No. 63-2

Issued: July 30, 1963

SUBJECT: SAFETY OF AILERON AND FLAP BOLTS

AIRPLANES AFFECTED: Model 23, M-1 through M-462

Figure 1. Outboard Aileron Hinge (LH Wing Shown with Wing Tip Removed)

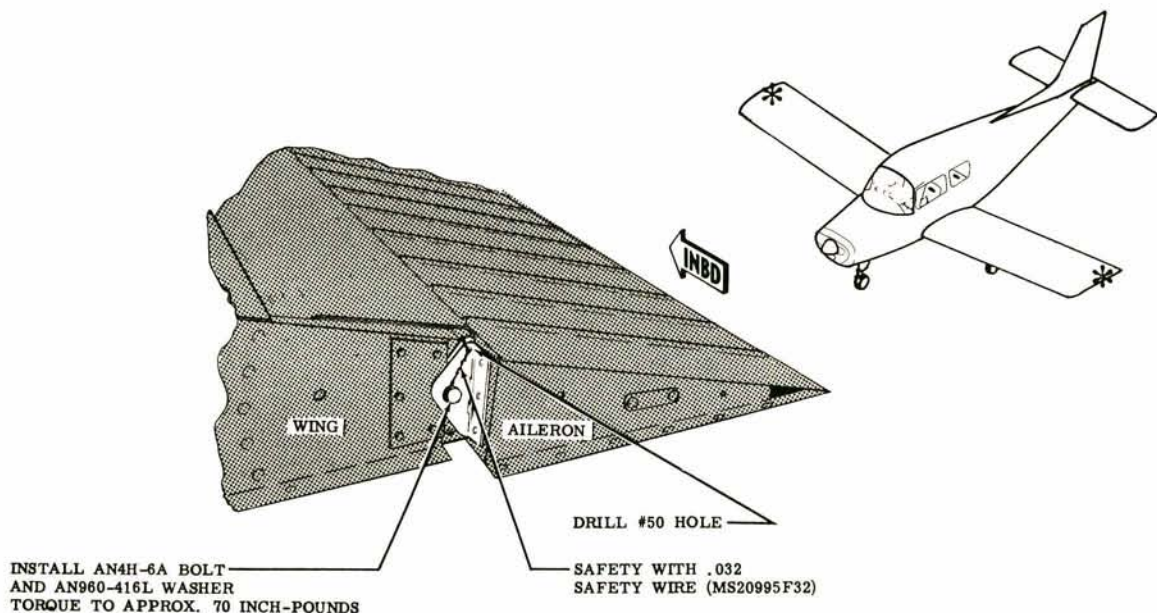
SAFETYING OF OUTBOARD HINGE BOLTS ON AILERON. (See Figure 1.)

- a. With the outboard end of each aileron adequately

supported, replace the outboard hinge bolts with AN4H-6A bolts. If AN4H-6A bolts are not readily available, the existing bolts can be drilled for safety wire with a #50 drill and reinstalled in the hinge. Be sure to re-install the AN960-416L washer under each bolt head. Torque the bolts to approximately 70 inch-pounds.

b. Drill a #50 hole in the outer segment of each aileron hinge at the approximate location shown in Figure 1 below.

c. Insert .032 lock wire (MS20995F32) through the hole in the bolt heads and safety to the newly drilled holes in the hinge.

Figure 2. Inboard End of Flap (LH Flap Shown Down)

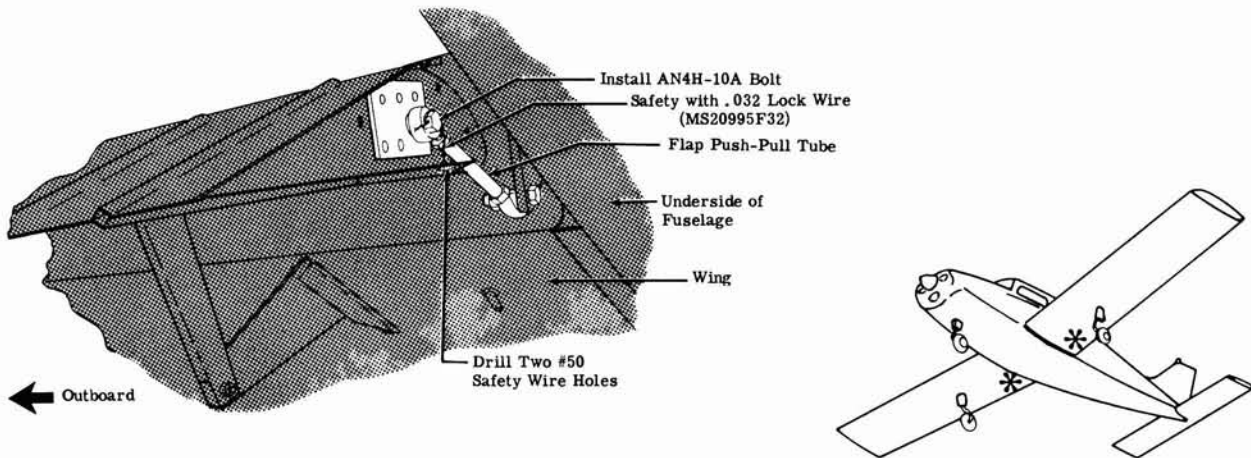
SAFETYING OF AFT ATTACH BOLTS ON FLAP PUSH-PULL TUBES. (See Figure 2)

- a. Remove the bolts that attach the flap push-pull tubes to the inboard end of each flap, and install AN4H-10A bolts in their place. If AN4H-10A bolts are not readily available, the heads of the existing bolts can be drilled for safety wire with a #50 drill.
- b. Drill two #50 holes approximately 0.20 inches apart in the flap skin at the approximate location shown in Figure 2. The holes should be drilled about 0.13 inches from the inboard edge of the flap skin.
- c. Safety the bolts as shown in Figure 2, using .032 lock wire (MS20995F32).

Figure 3. Access Hole for Aileron Bellcrank Pivot Bolt (Underside of LH Wing Shown)

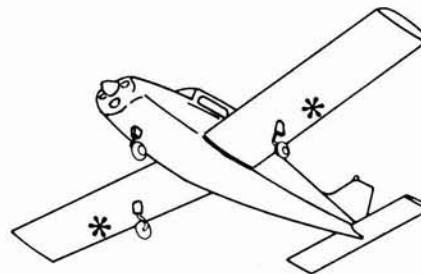
REPLACEMENT OF NUTPLATE WITH LOCKNUT ON AILERON BELLCRANK PIVOT BOLT.

- a. Drill a 0.875 inch diameter hole in the lower wing skin, directly below the bellcrank pivot bolt to permit access to the nut end of the bolt. (See Figure 3 for exact location.) Remove the existing access cover from the top side of the wing to permit access to the head of the pivot bolt.
- b. Drill out the nutplate attaching rivets, and remove the nutplate from each pivot bolt without removing the bolt from the bellcrank mounting bracket. If the bolt is removed from the hole in the lower bellcrank bracket, the aileron cables will have to be loosened and then rerigged in accordance with the Model 23 Owners Manual.
- c. Install an AN365-428C nut and AN960-416 washer on each bolt.
- d. Reinstall the access cover above the pitot bolt, and install a BS48155 plug in the newly drilled access hole below the pivot bolt.
